Subject: AP1000 COL Response to Request for Additional Information (TR 29)

Westinghouse is submitting a revised response to the NRC request for additional information (RAI) on AP1000 Standard Combined License Technical Report (TR) 29, APP-GW-GLR-044, Nuclear Island Basemat and Foundation. This RAI response is submitted in support of the AP1000 Design Certification Amendment Application (Docket No. 52-006). The information included in the response is generic and is expected to apply to all COL applications referencing the AP1000 Design Certification and the AP1000 Design Certification Amendment Application.

RAI Response Number: RAI-TR29-SRSB-01
Revision: 1

Figure 1-1
Steam Line Break

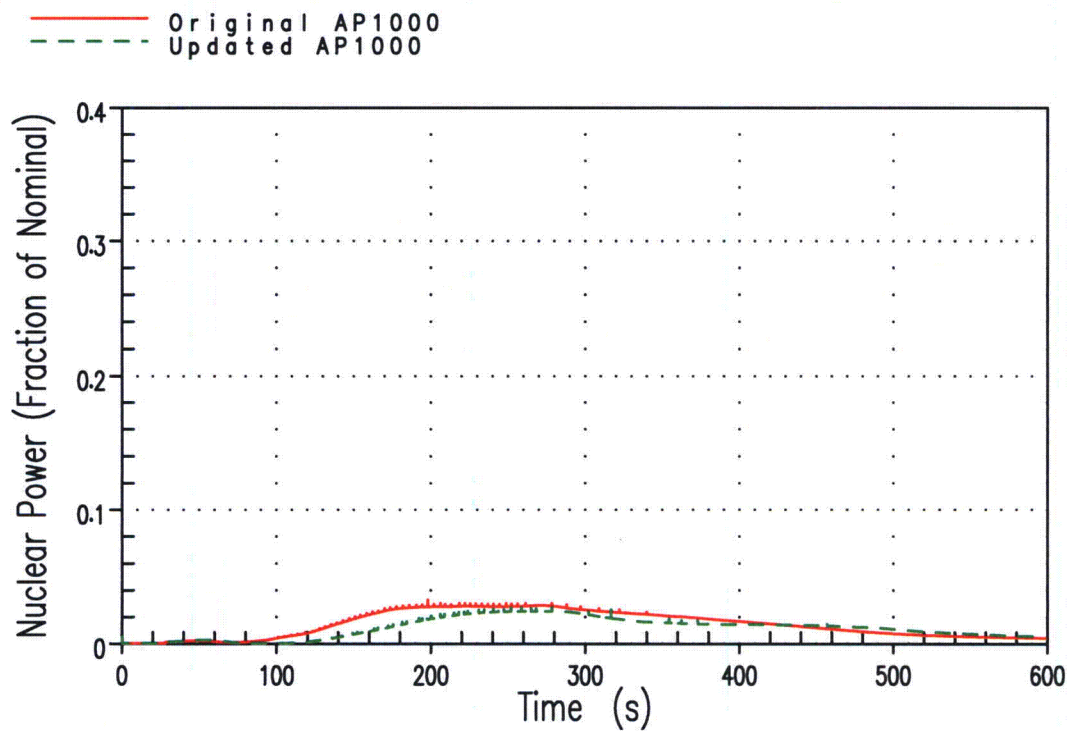
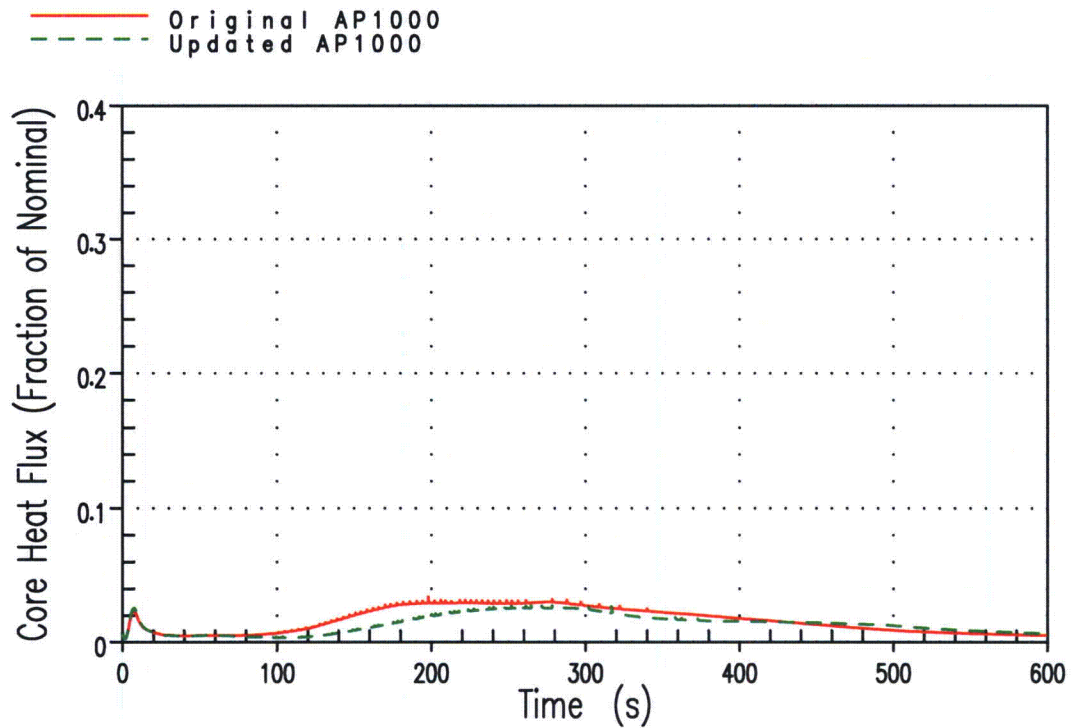
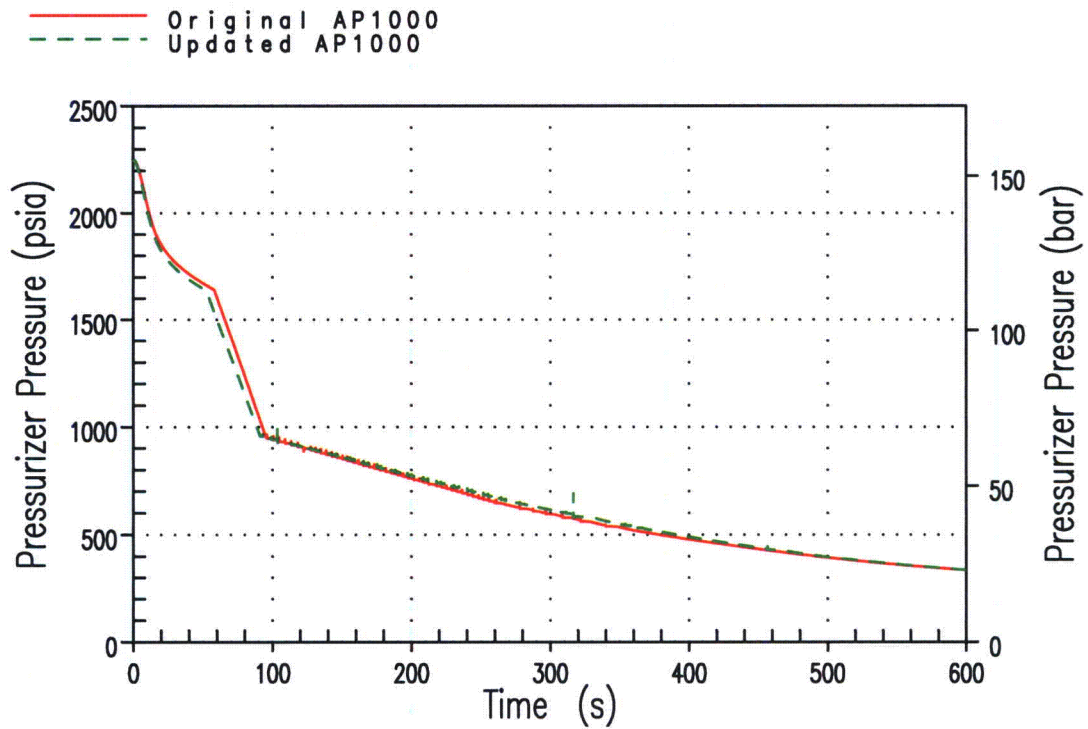
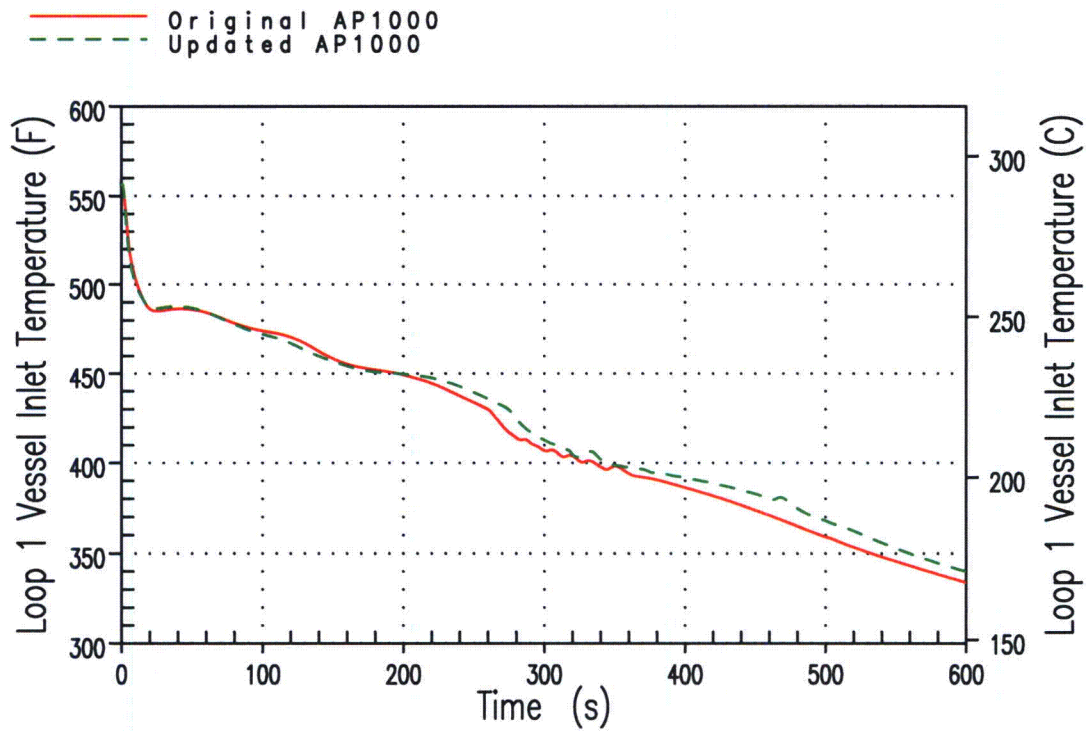
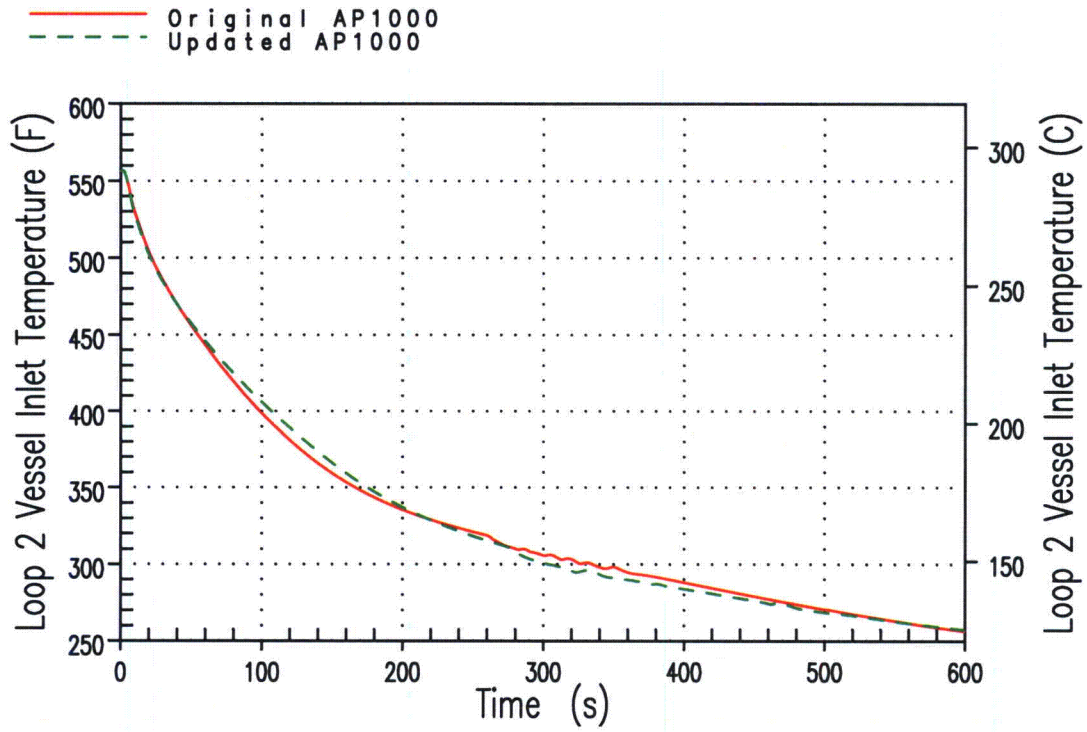
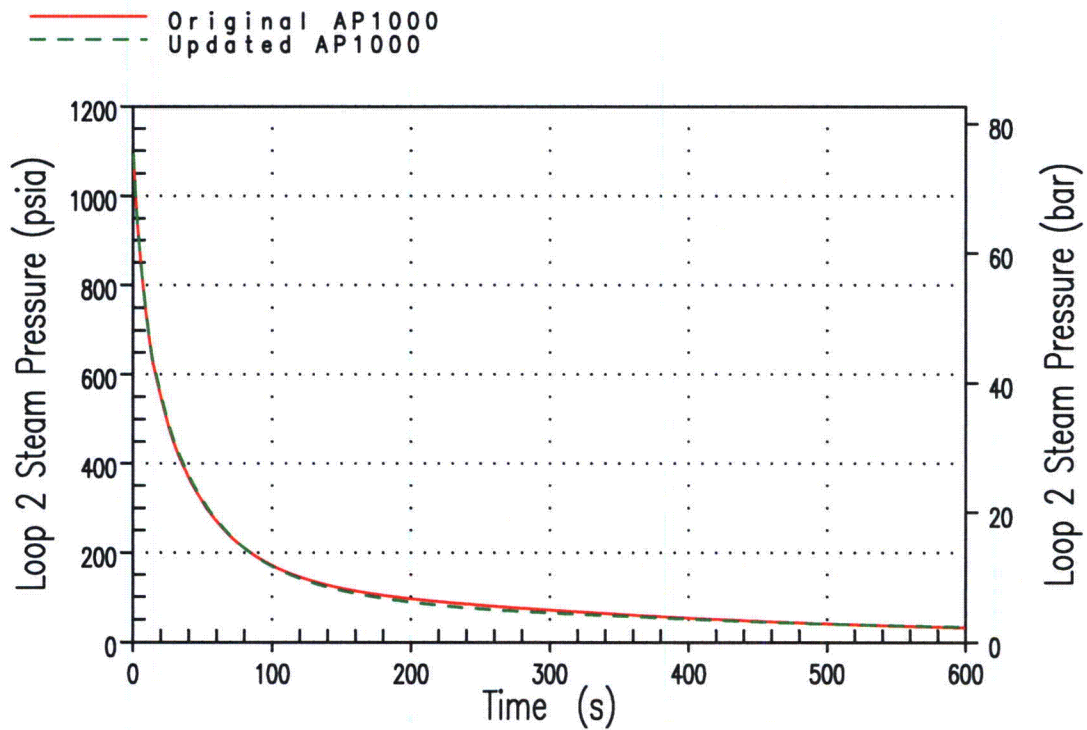
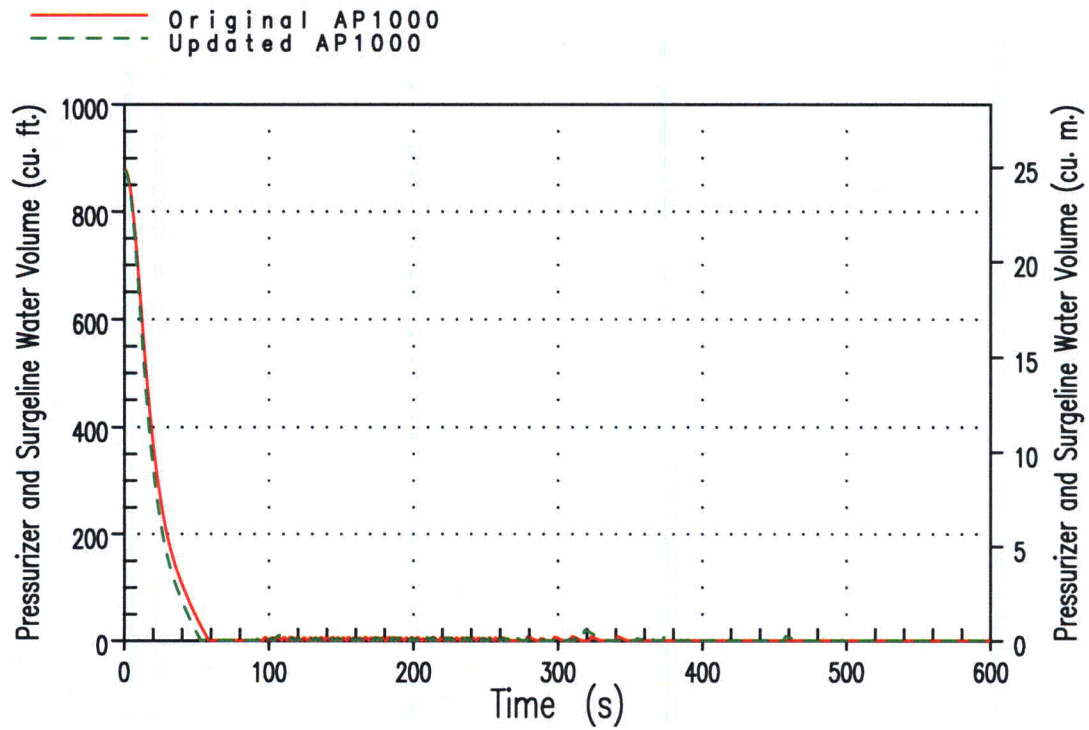
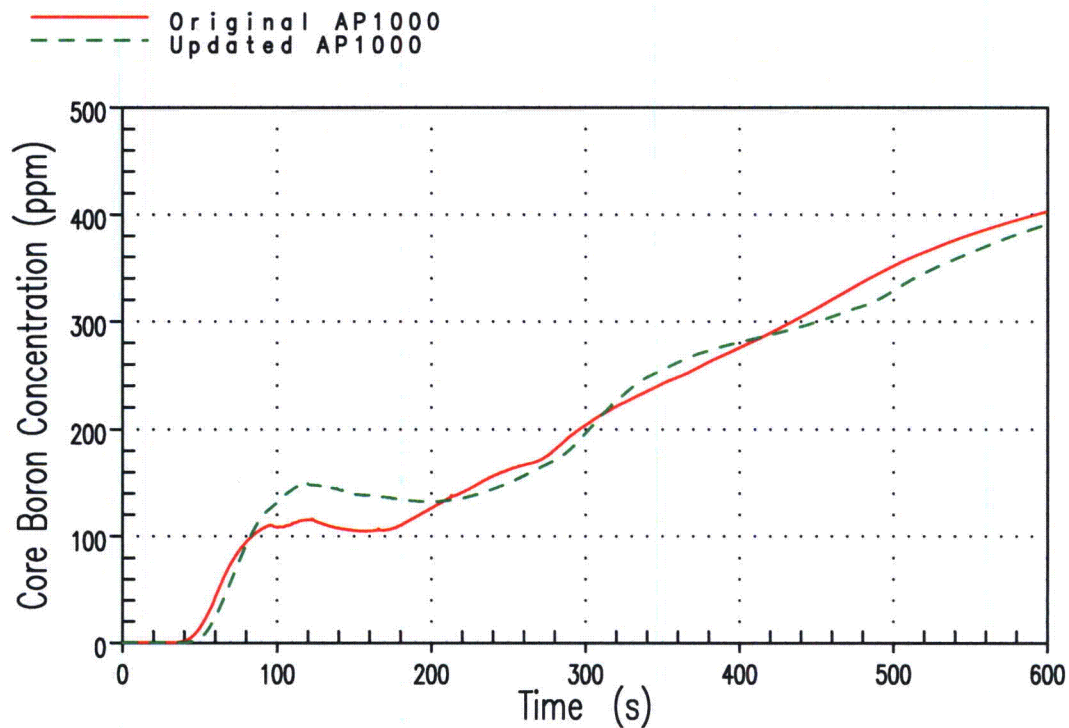
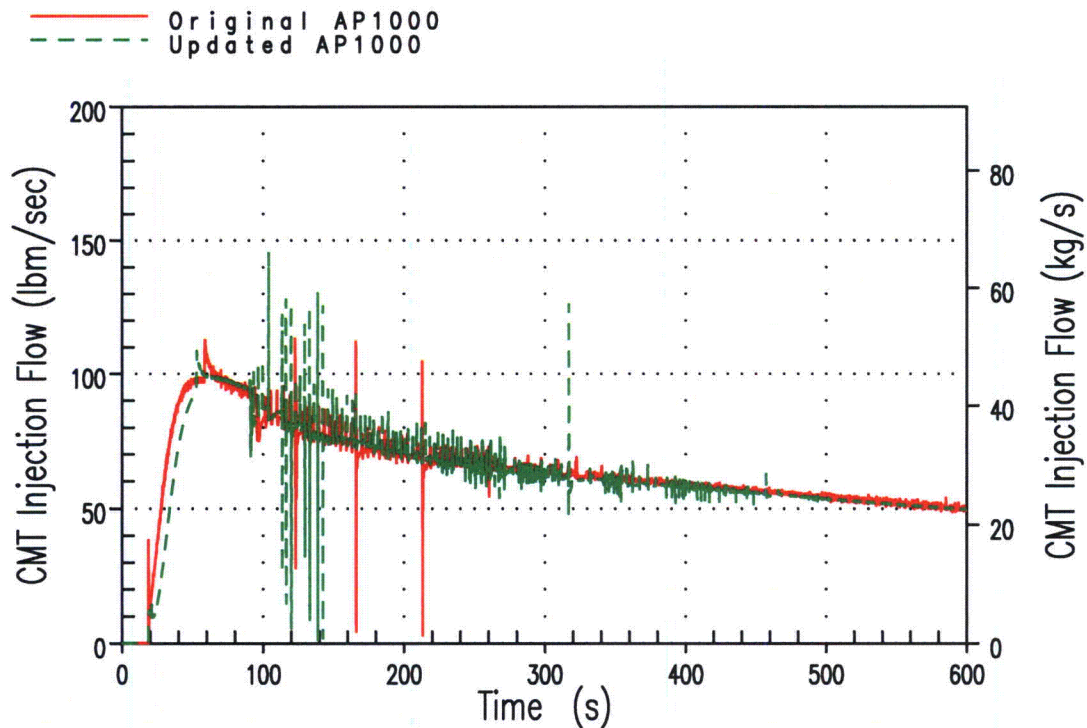
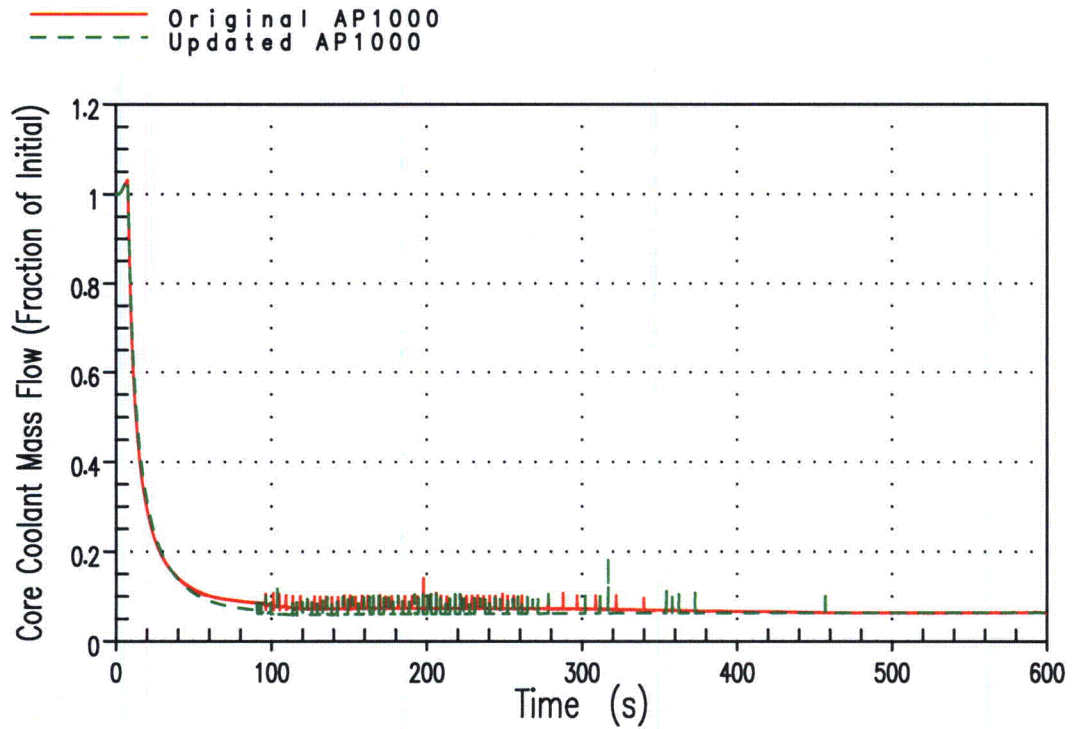
Please provide an evaluation of the impacts of these proposed changes on the analysis results of each of the transients and accidents in DCD Chapter 15. The evaluation should demonstrate either the analysis results of DCD Chapter 15, Revision 15, remain bounding and valid, or the effects of these changes are insignificantly small that the applicable acceptance criteria for these transients and accidents remain complied with.

The transient results of the updated plant configuration during a steam line break are very similar to those of the original plant configuration. Core state parameters (inlet temperature, pressure, flow, and boron concentration) remain essentially the same. The return to criticality occurs at essentially the same time in the updated AP1000 configuration. Following the return to criticality, the core power is slightly less for the updated AP1000 (see Figures 1-1 and 1-2). Based on these results, the DNB ratio will continue to meet the acceptance criteria with the revised AP1000 configuration.
